5 - 7 STATION ROAD, HAYLING ISLAND

MIXED-USE DEVELOPMENT

Transport Statement

PWPA/18/4652s

Figure 2.1: PIA Distribution

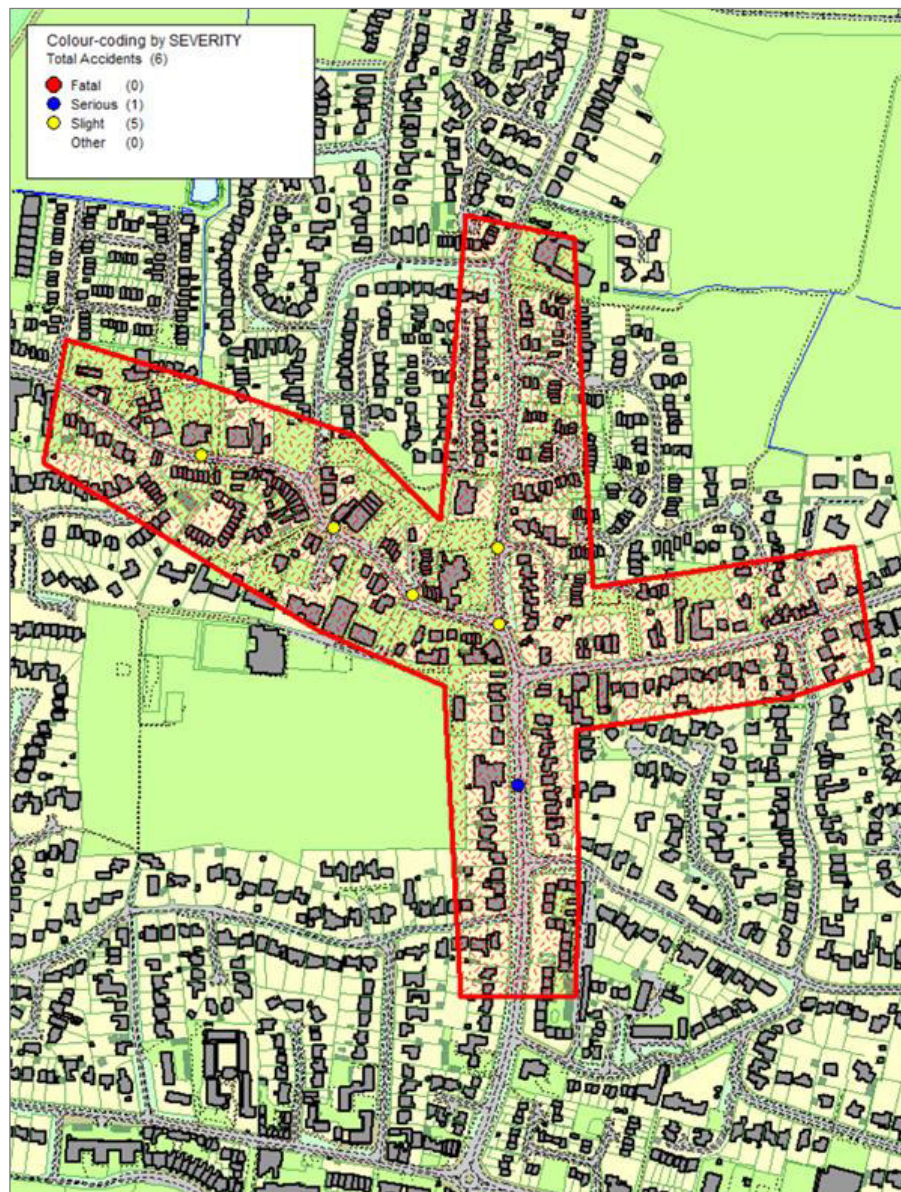
"Personal Injury Accident Data (PIA data) has been collected for a 5-year period between January 2013 and December 2017. It is noted that this data is a year and a half out of date and should therefore be updated to confirm there have been no recent accidents in the vicinity of the site which could indicate an existing safety issue. PIA data should be obtained from Hampshire Constabulary who provide the most up-to-date accident data."

2.2.2 PIA data has been obtained from Hampshire Constabulary for the most recent 5 years. The location of the incidents relative to the site is displayed on **Figure 2.1** and the full accident report is attached at **Appendix C**.

- 2.2.3 A total of 6 PIAs have been recorded in the 5-year period, comprising of 1 'serious' incident and 5 'slight' incidents. The full collision data report is attached at **Appendix C**. The PIA record does not reveal any pattern that in terms of distribution, severity or cause that could be exacerbated by the proposed development.

Drawing Status	FINAL		
Client	PWP Architects		
Project	5 - 7 Station Road, Hayling Island		
Drawing Title	Site Overview		
Scale	1:250	Date	Sept 19
Drawn By	SMO	Checked By	ALB
Drawing No.	2018-4652-001		Rev.
		B

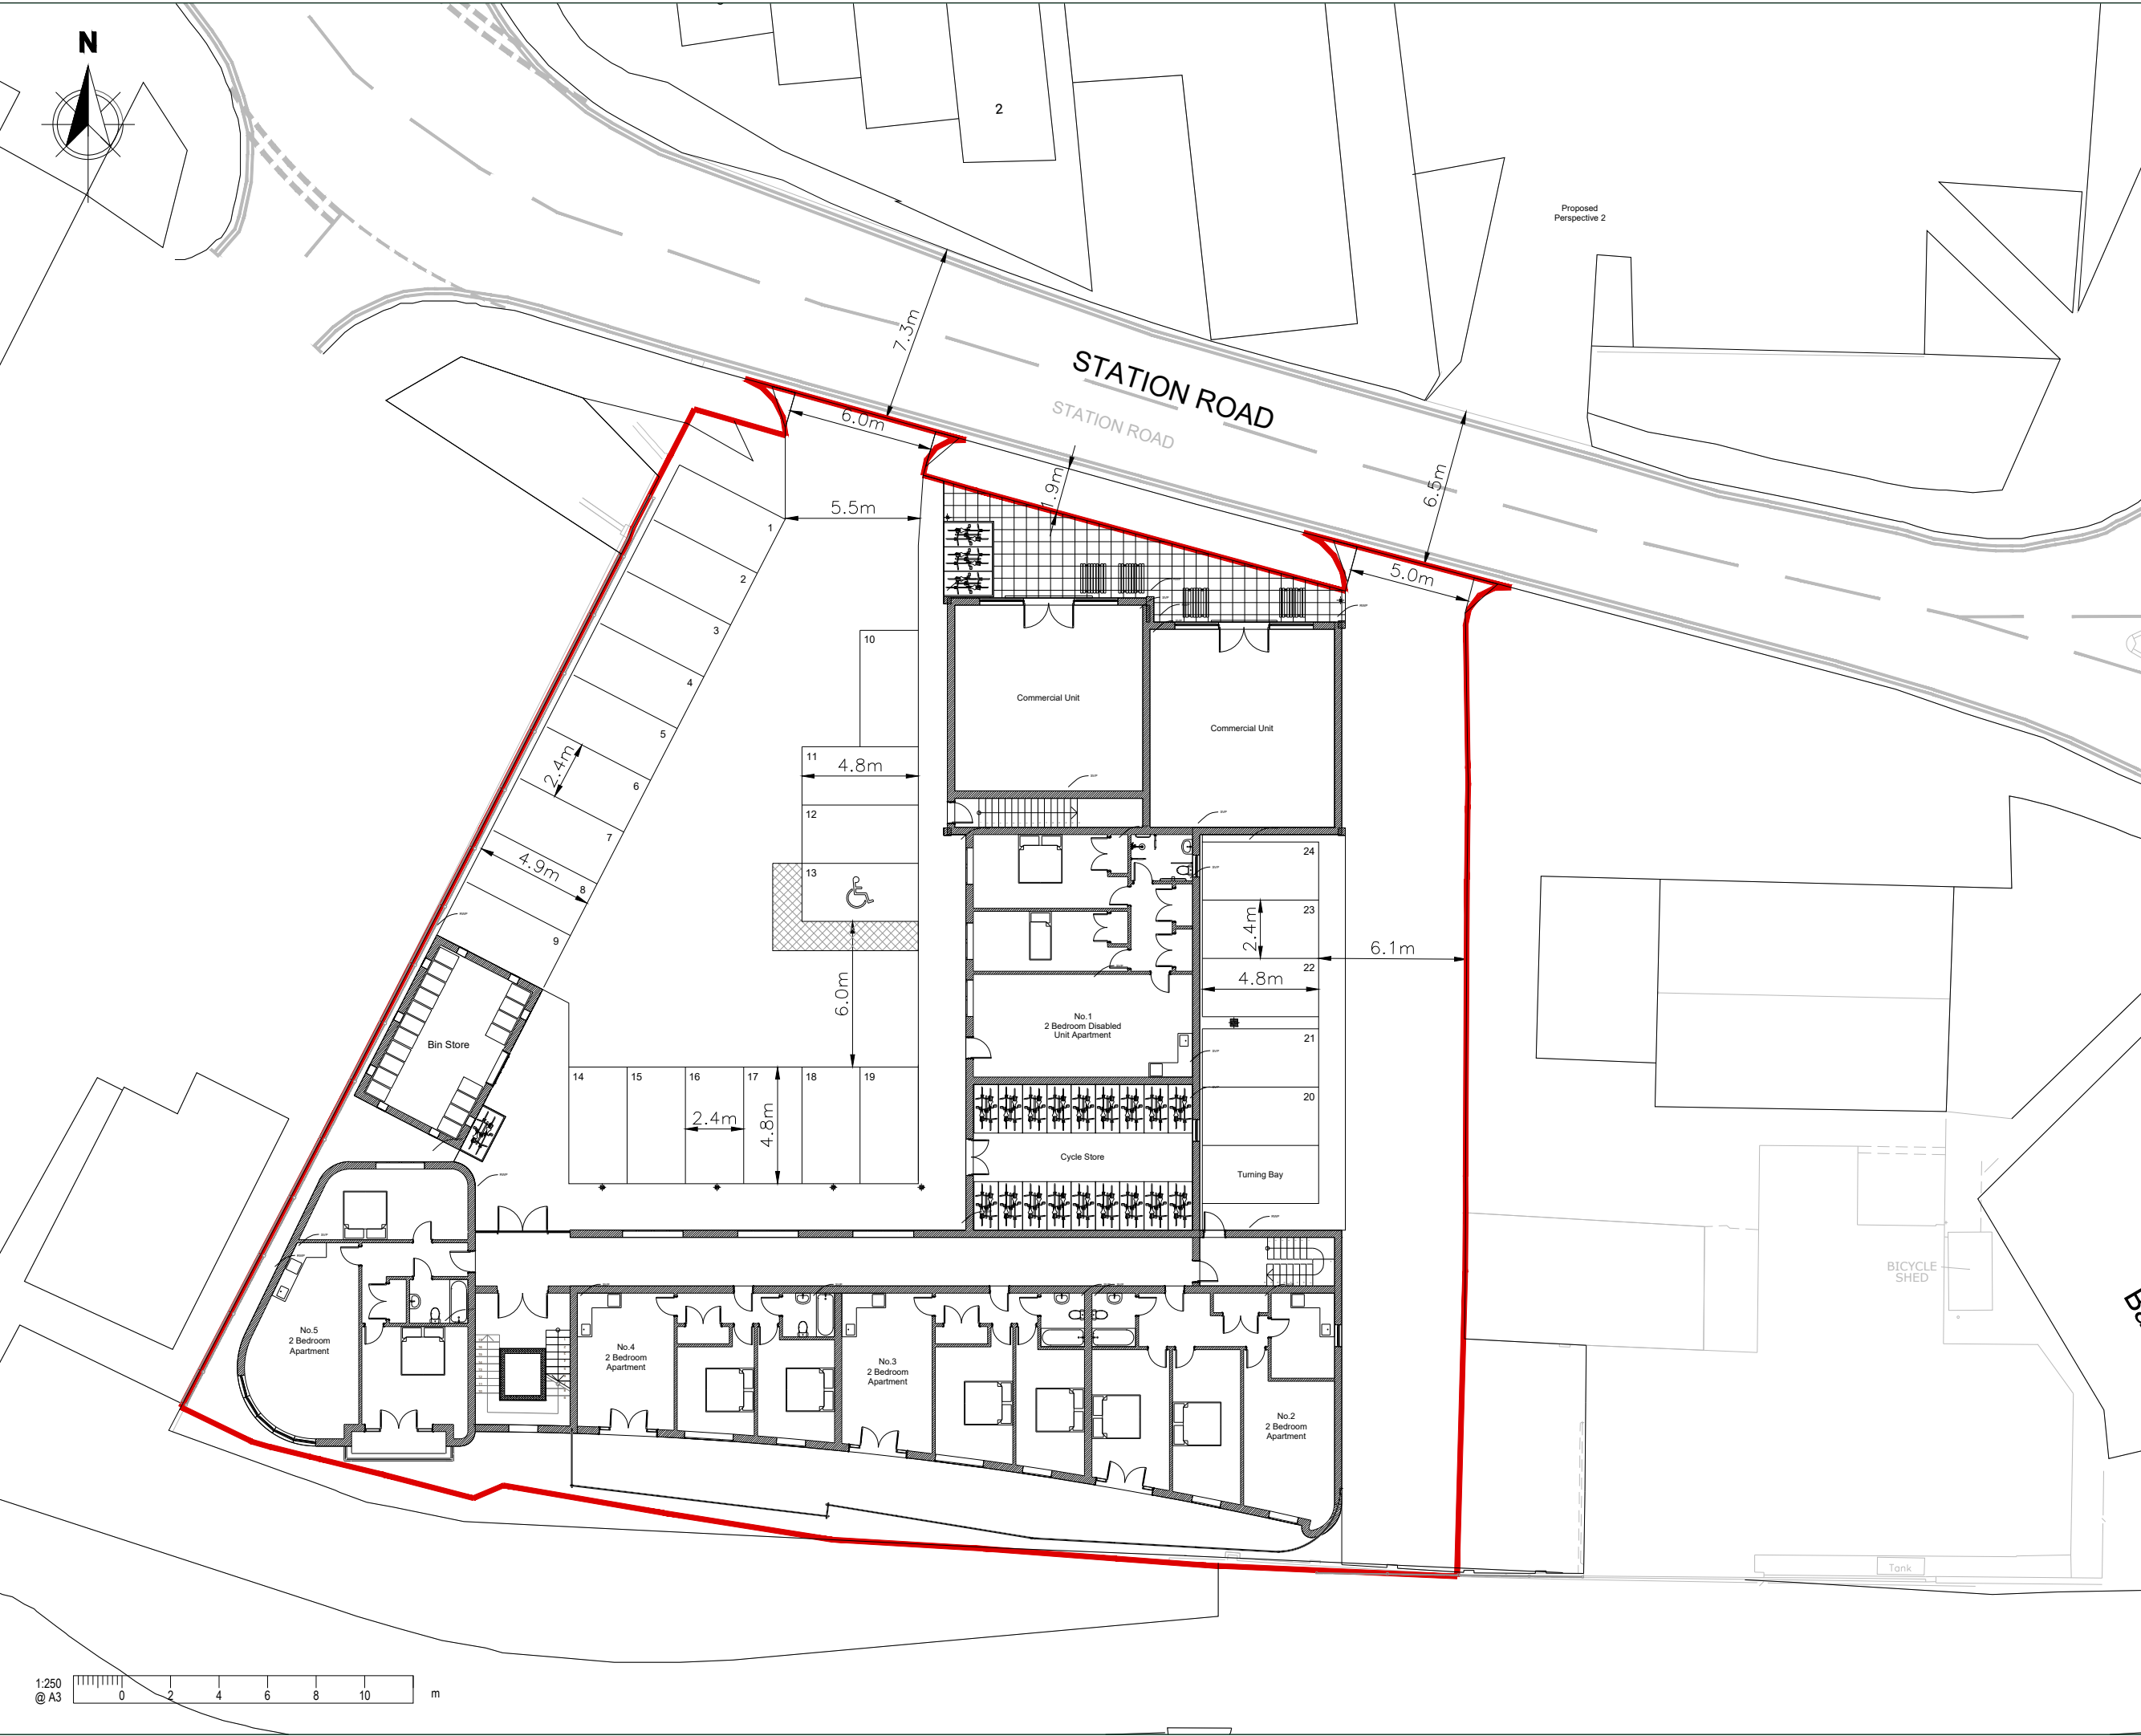
"The existing site is served by a 2m footway flanking station road. The footway directly accessing the development is predominantly flush kerbs. As part of the access works, the kerbing along this footway should be rationalised and a consistent width provided to ensure safe and level pedestrian access into the development."

"The site is currently served by 2 extended dropped kerbs. To formalise these access points, it is proposed to reduce the width of the western access to 6m and the eastern access to 5m. Any remaining section of dropped kerb in between these access points should be reinstated to distinguish where the eastern and western vehicular access points are."

2.1.2 The width of the footway on the site frontage would be retained and the kerb adjacent to the site accesses will be reinstated with full height kerb stones. The footway is shown in **Drawing 2019/4652/001**.

- 2.3.2 The kerb adjacent to the site accesses will be reinstated with full height kerb stones as shown in **Drawing 2019/4652/001**.

Drawing Status	FINAL		
Client	PWP Architects		
Project	5 - 7 Station Road, Hayling Island		
Drawing Title	Visibility Splays		
Scale	1:250	Date	Sept 19
Drawn By	SMO	Checked By	ALB
Drawing No.	2018-4652-002		Rev.
		B

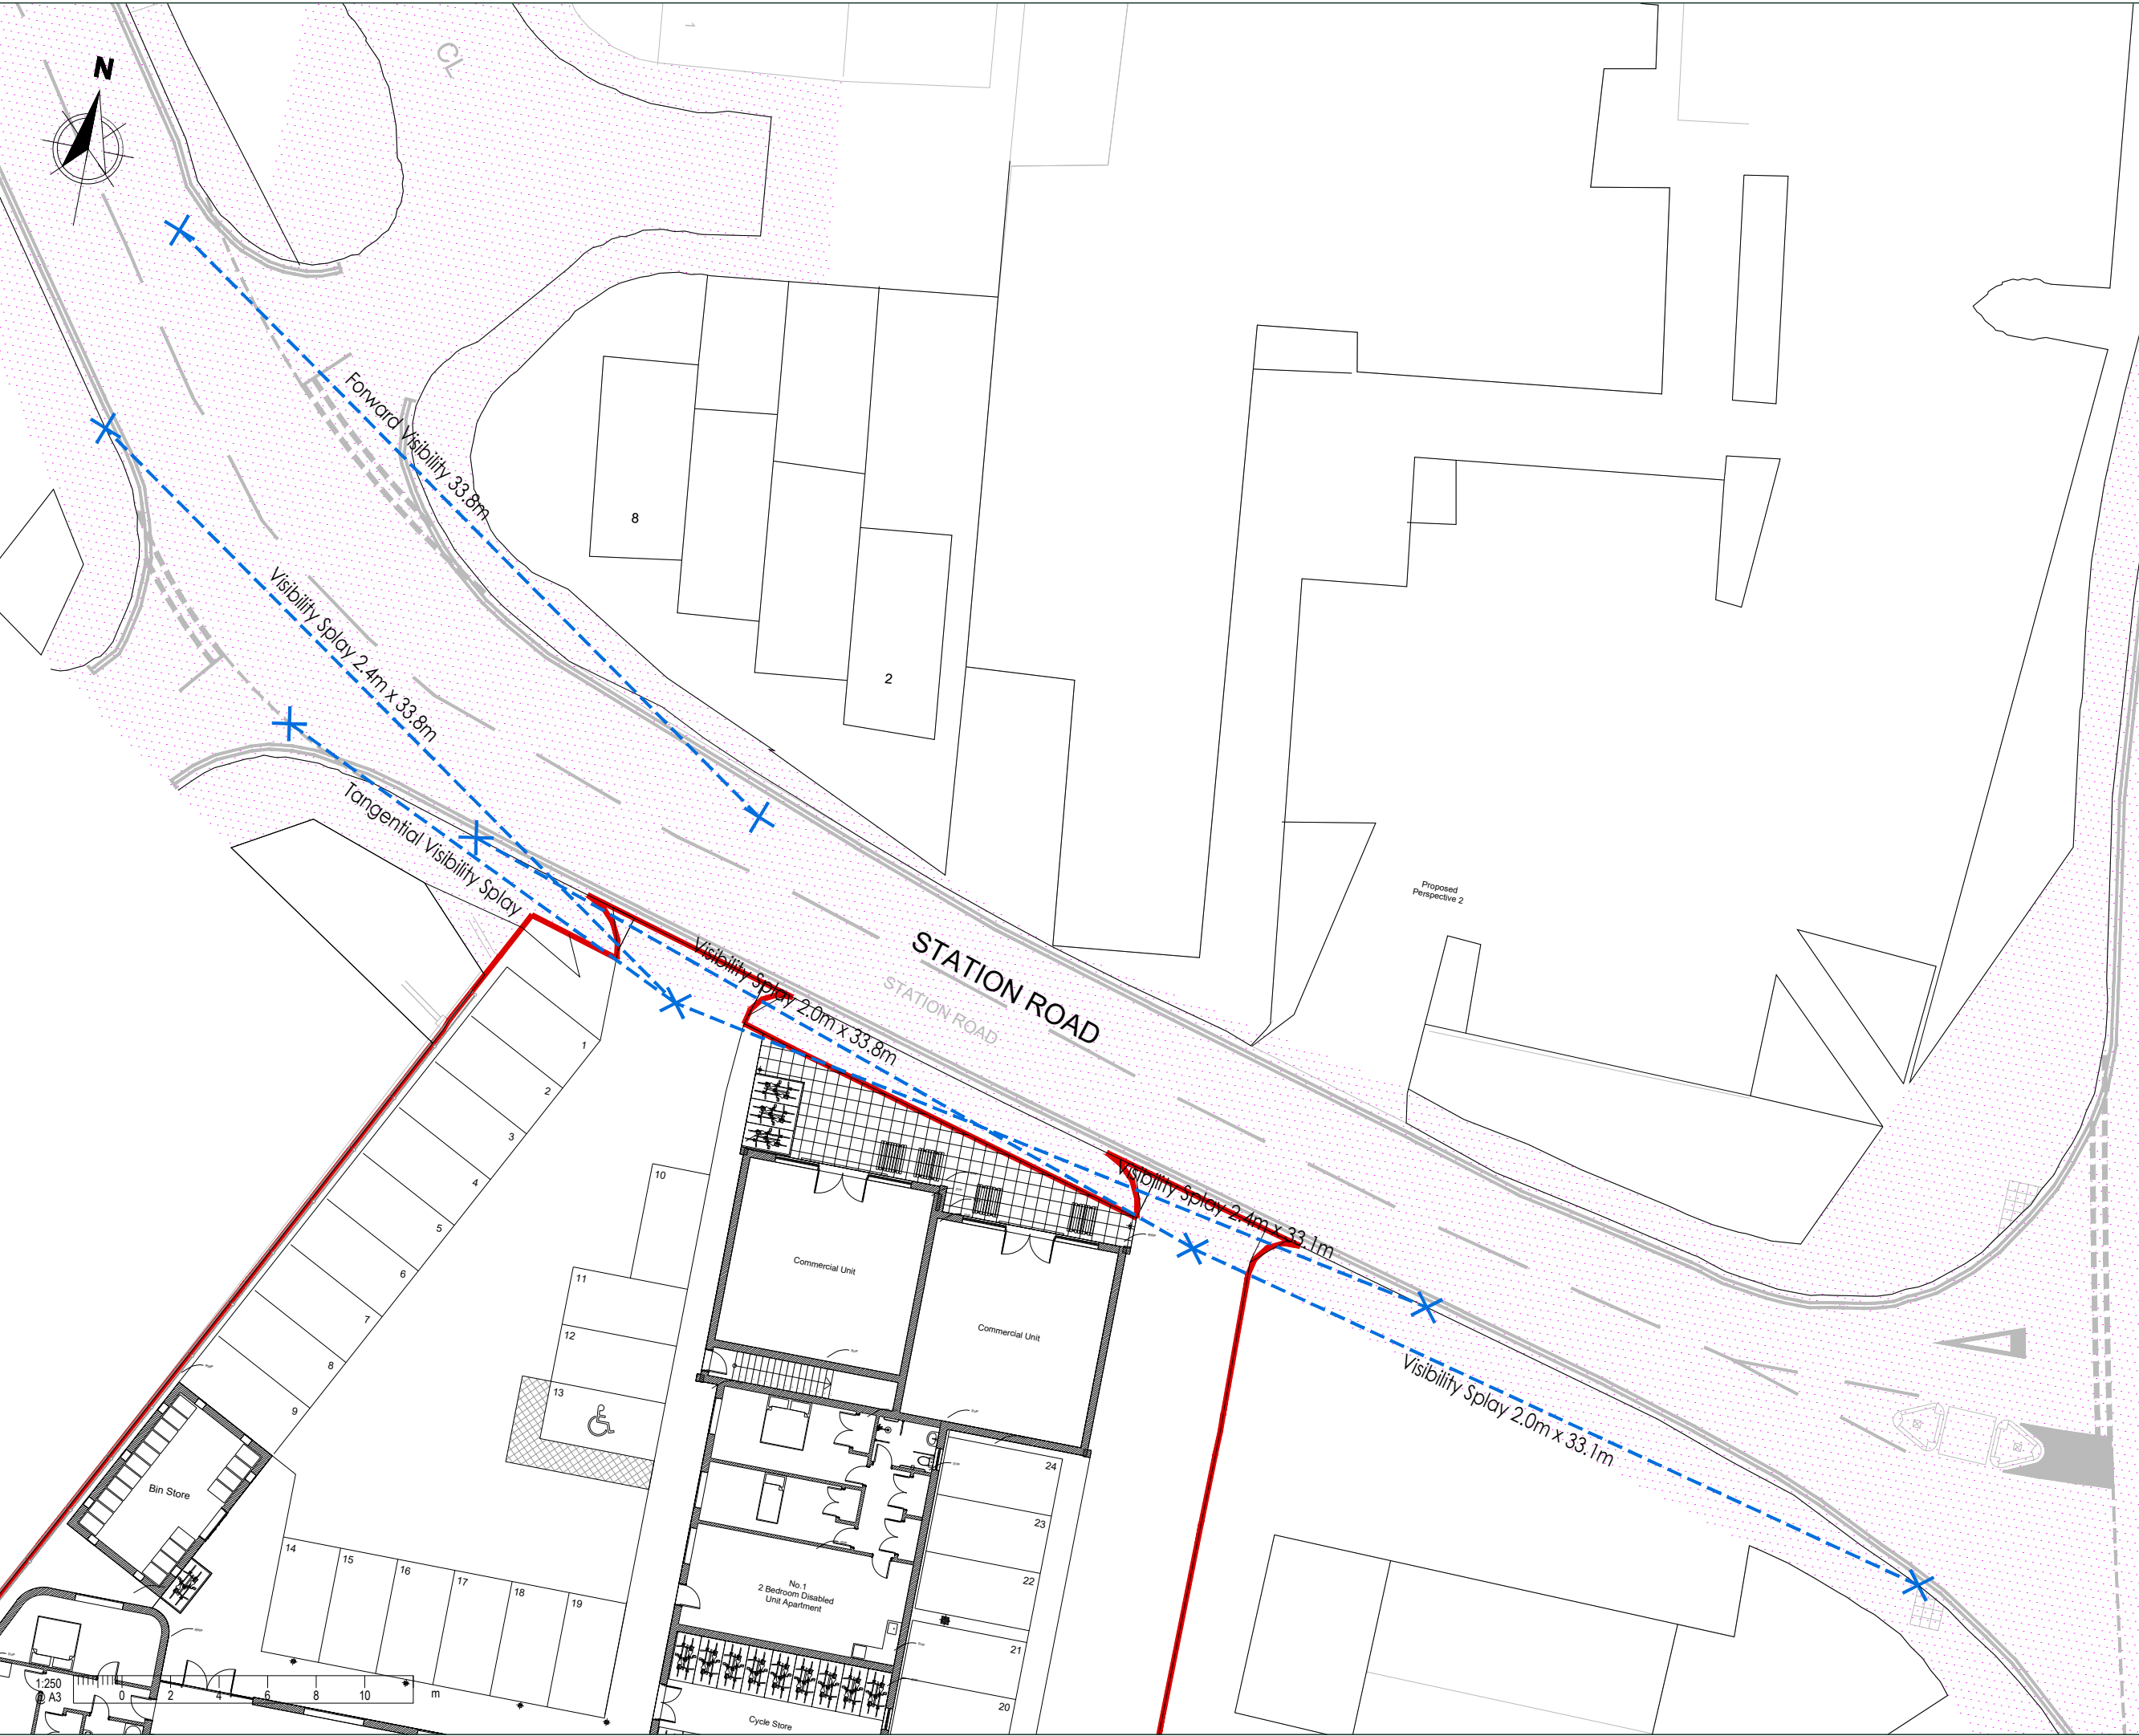
"Visibility is demonstrated at 2.4m x 43m commensurate with the 30mph speed limit on Station Road. Confirmation is required that the visibility splays are provided within the extents of the highway and do not cross private land. Recorded speeds along Station Road are required to confirm whether the visibility splays proposed are sufficient for the speed of the road."

- 2.3.6 To establish traffic volumes and design speeds in the vicinity of the site, Bright Plan commissioned 'Modal Data' to conduct an Auto Traffic Count (ATC) survey between 9th – 15th September 2019 on Station Road. A summary of the ATC data is provided in **Figure 2.2** and the full ATC data output is attached at **Appendix E**.

- 2.3.7 Using the calculation coefficients set out in MfS, a stopping site distance (adjusted for bonnet length) of 33.1m would be required looking the east, and 33.8m would be required looking the west within the land under the control of the applicant and the public highway. The required visibility splays are demonstrated as achievable in **Drawing**
